RE: Hanford Challenge, NRDC, and Columbia Riverkeeper Comments on the *Draft Waste Incidental to Reprocessing Evaluation for Vitrified Low-Activity Waste*

Hanford Challenge (HC), the Natural Resources Defense Council (NRDC), and Columbia Riverkeeper (CRK) write today to comment on the Department of Energy's (DOE's) *Draft Waste Incidental to Reprocessing Evaluation for Vitrified Low-Activity Waste* (Draft WIR Evaluation) (comment deadline extended to November 27, 2020).

Below: IDF Conceptual model (PA 2019 Fig. 4-3)

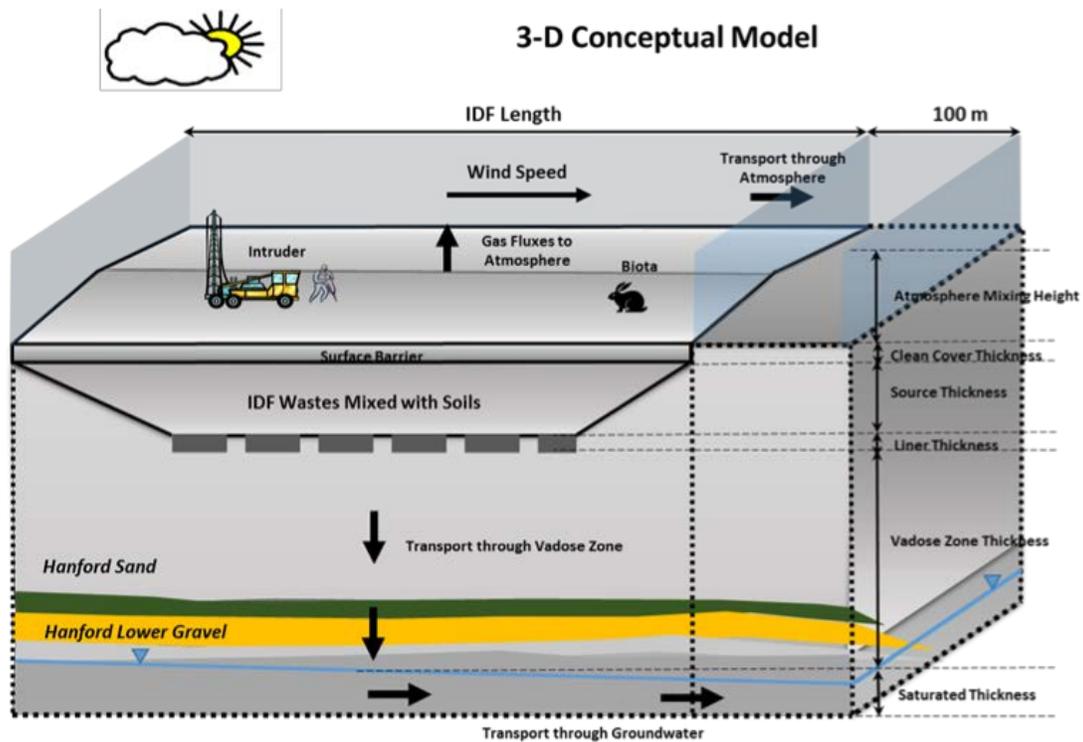
The surface barrier life assumed to be 10,000 years, with partial failure at closure + 500 years. The assumed infiltration rate through the surface barrier of the IDF is 0.5 mm per year, and 75 mm per year at the edge of the barrier (Battelle 1995, PA sec. 5.2.1 p. 5-178). Each doubling of the infiltration rate results in a $45\% \pm 5\%$ increase in the amount of Tc-99 reaching the saturated zone (PA 2019 p. 1-22).

An inadvertent intrusion may result in an acute dose of up to 500 mrem. The same intrusion can also locally increase the infiltration rate. If an intrusion damages the IDF surface barrier (for all or part of the IDF) the resulting infiltration rate would increase up to the rate at the barrier edge, which is 75 mm per year. This would increase the amount of Tc-99 reaching the saturated zone by as much as $(75 \text{ mm} / 0.5 \text{ mm}) \times 0.45 = 67.5$ times. Note that the 2019 PA uses a maximum infiltration rate of 3.5 mm per year, which is assumed for the surface barrier after closure + 500 years.

This increase causes the project to exceed the all-pathways dose in the post-compliance period of 3051 to 12051 at the 100-meter downgradient exposure point. The current groundwater pathway dose for that period is 1.5 mrem per year versus a maximum of 25 mrem per year. Recall that this maximum value assumes that no other Hanford sources contribute to dose. At the 75 mm per year infiltration rate the 100-meter exposure point dose potentially rises to greater than 100 mrem per year. The unacceptable post-intrusion dose due to Tc-99 at the 100-meter exposure point would also likely arrive sooner than in the base case, potentially pushing the excess dose (greater than 25 mrem per year) into the compliance period of 2051 to 3051. Note that this discussion details the effect on the maximum public offsite dose. This is distinct from discussions in the IDF PA regarding the onsite maximum dose to an intruder or future rancher.

Figure 1-2. Atmospheric Pathway Dose During the 1,000-Year Compliance Period.

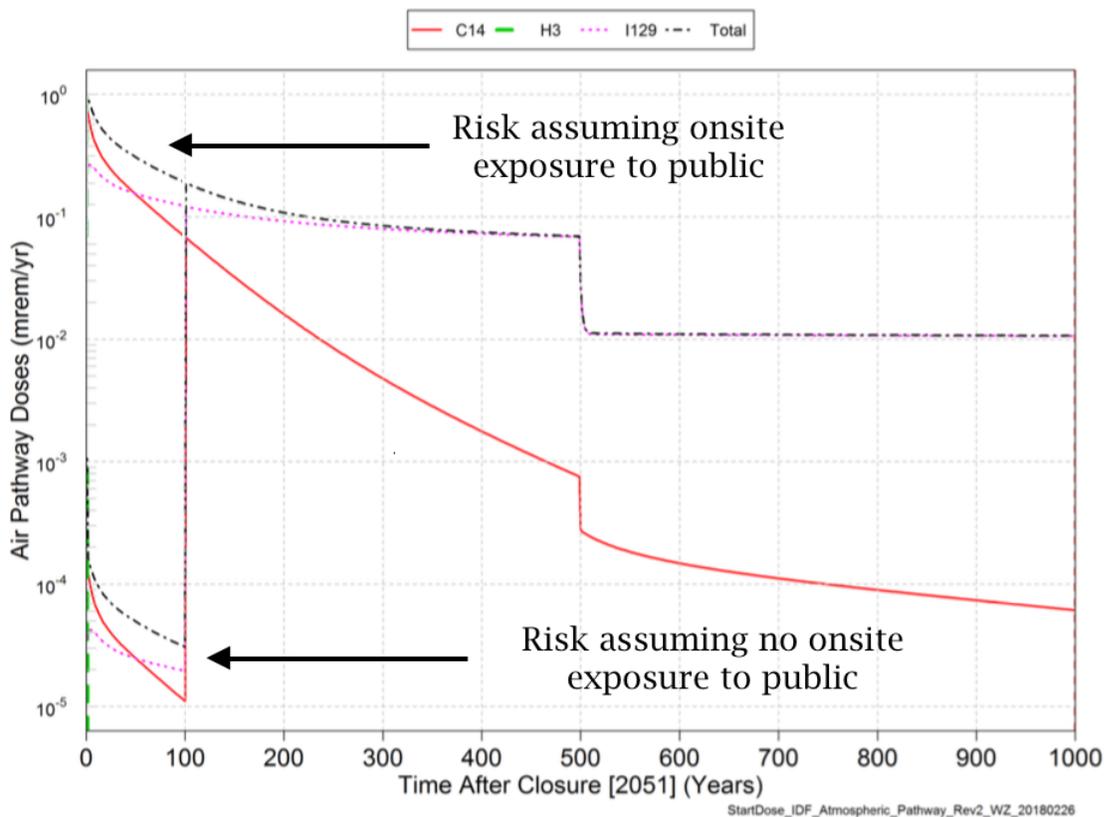
Likewise, DOE assumes no onsite exposure to members of the public before 2151. In fact the DOE model is extremely sensitive to any failure to successfully exclude members of the public from the site for the next 130 years. For this first 100-years of operation after 2051, the nearest receptor (member of the public) is assumed to be 20 kilometers from the IDF. After that, the theoretical receptor is moved to within 100 meters of the IDF. If the DOE fails to keep members of the public

away from the IDF in 2051, the modeled dose (via air contamination) increases by about 10,000 times (PA 2019 p. 1-12). This increased risk is shown graphically on the following page, using an adaptation of Figure 1-2 from the 2019 IDF Performance Assessment.

This implies that site security is a critical failure risk for the IDF, and requires substantial attention and guarantees prior to committing to opening of the IDF.
